# HUNTER H 36

DRAWING TITLE: H 36 SAILPLANS

SCALE: 0.042 HUNTER PART NO. TBD REVISION: - DRAWING NO. 356\_SAILPLAN

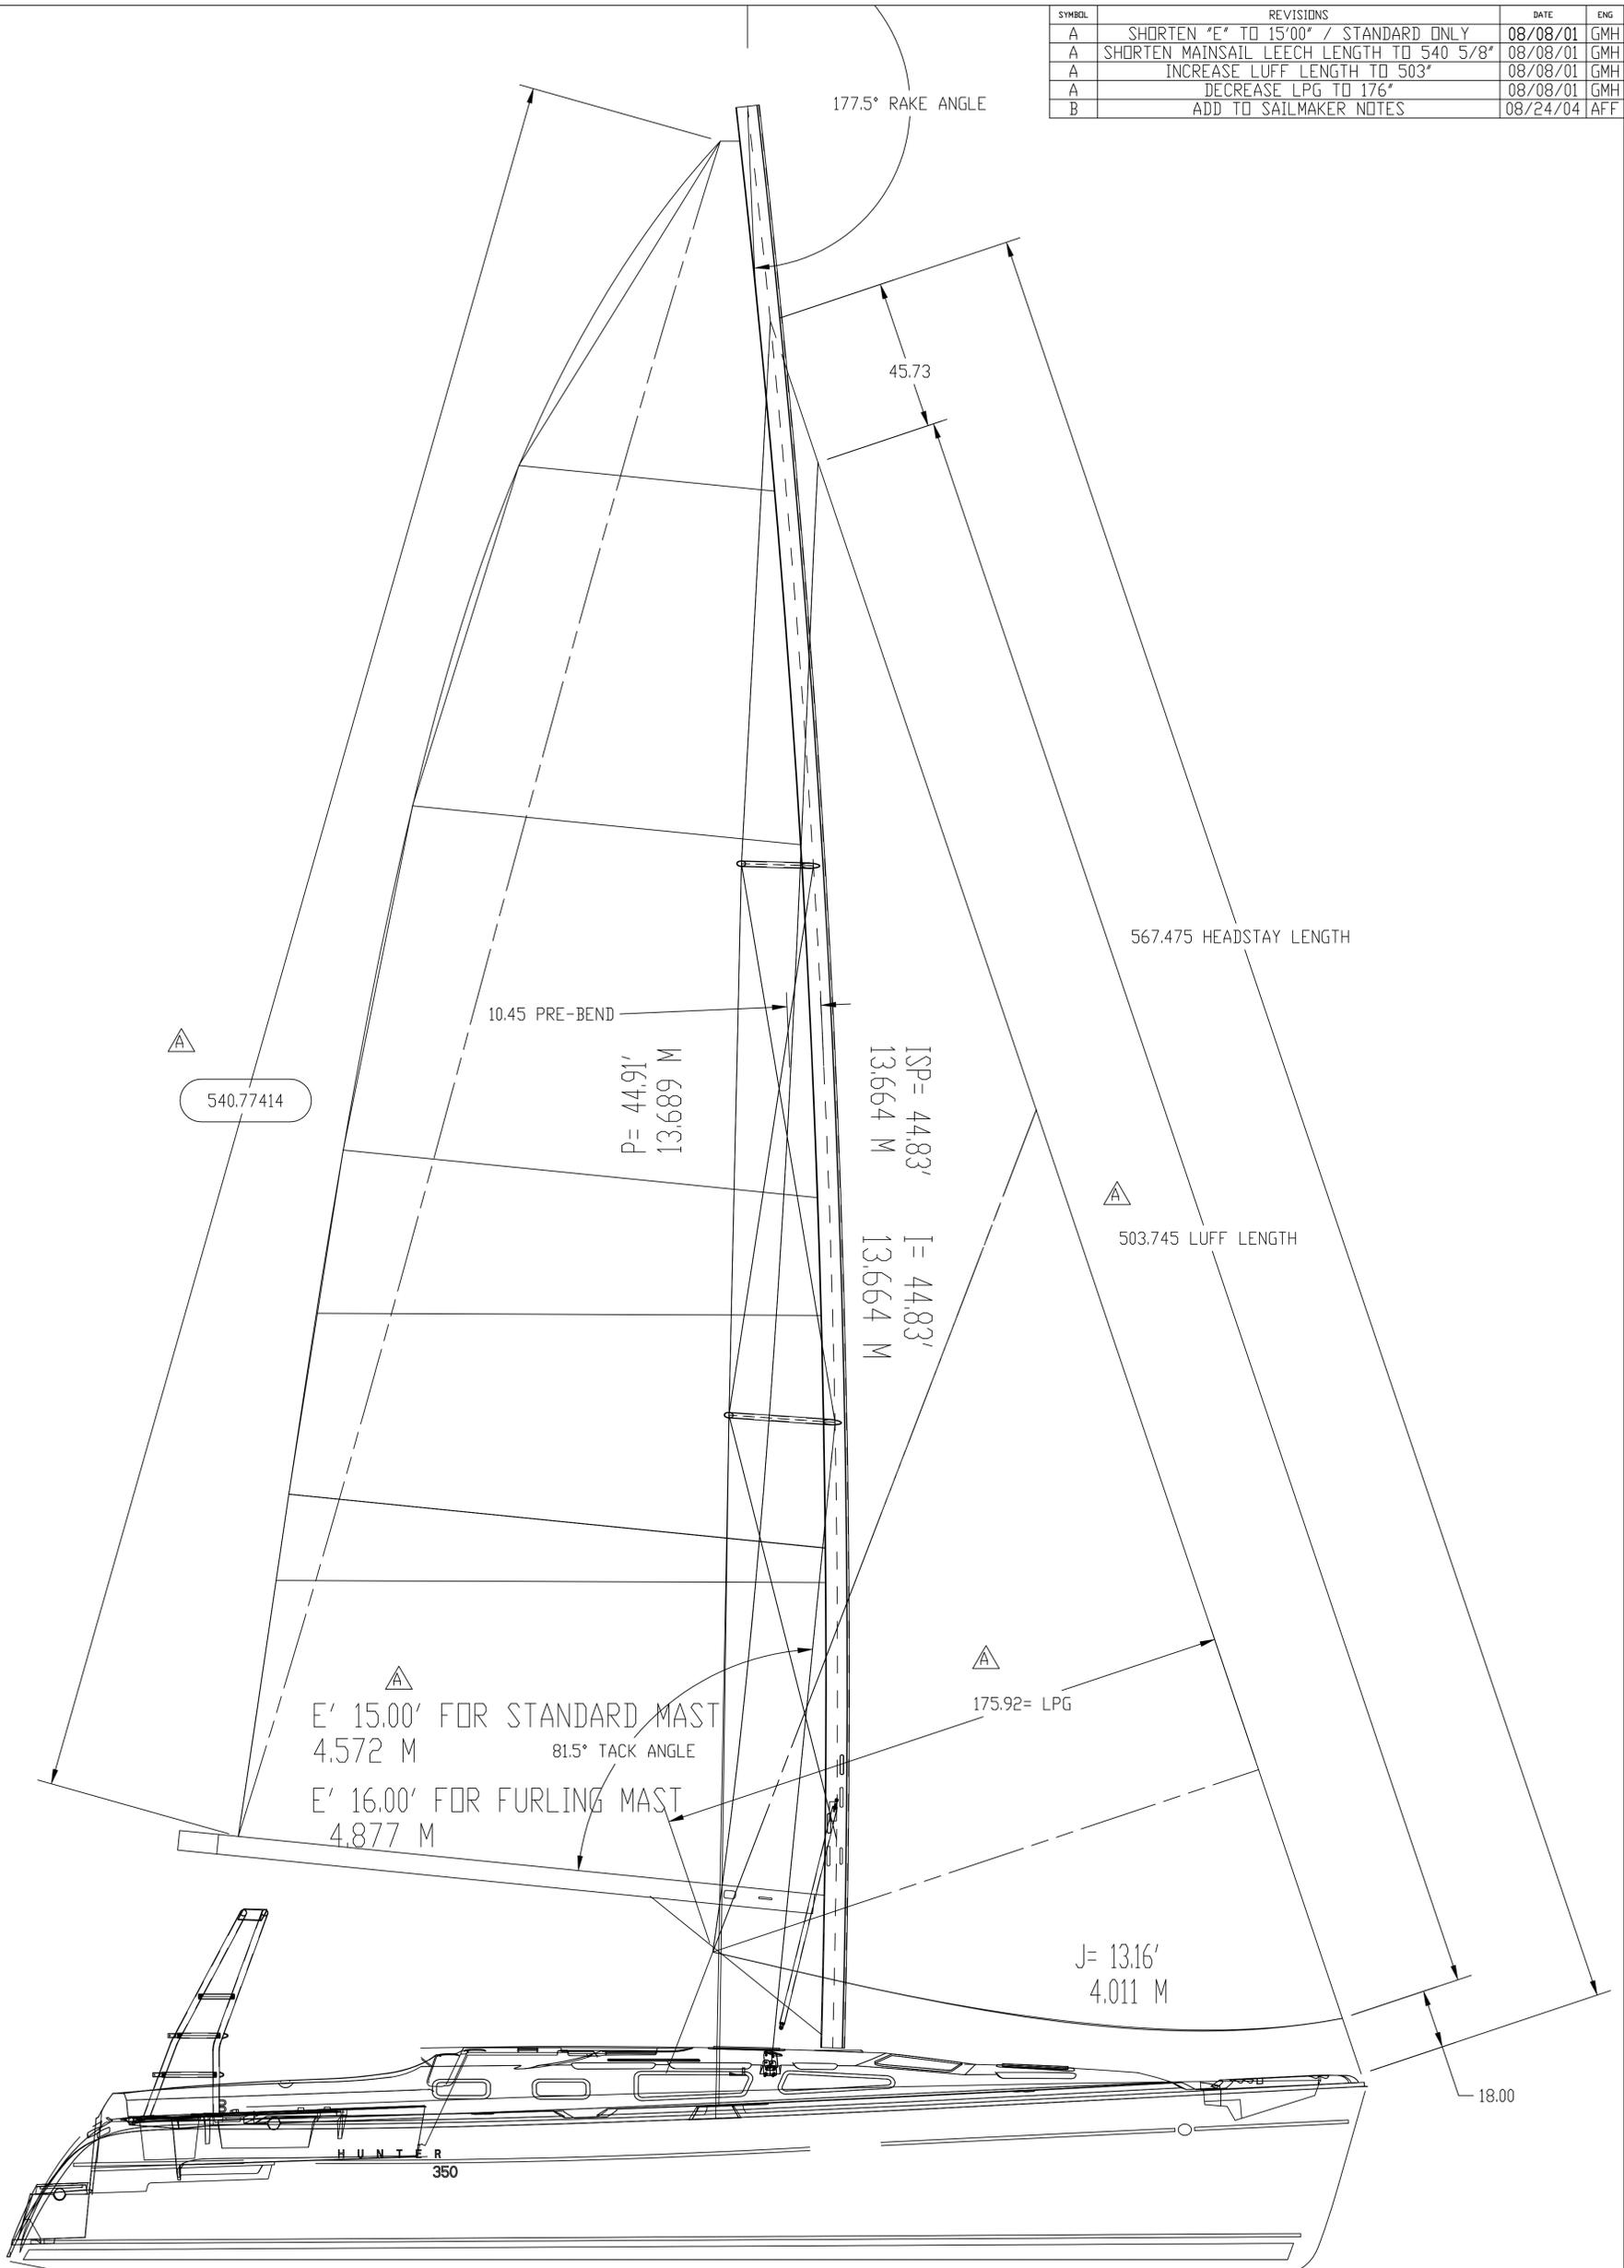
SYMBOL	REVISIONS	DATE	ENG
A	SHORTEN "E" TO 15'00" / STANDARD ONLY	08/08/01	GMH
A	SHORTEN MAINSAIL LEECH LENGTH TO 540 5/8"	08/08/01	GMH
A	INCREASE LUFF LENGTH TO 503"	08/08/01	GMH
A	DECREASE LPG TO 176"	08/08/01	GMH
B	ADD TO SAILMAKER NOTES	08/24/04	AFF
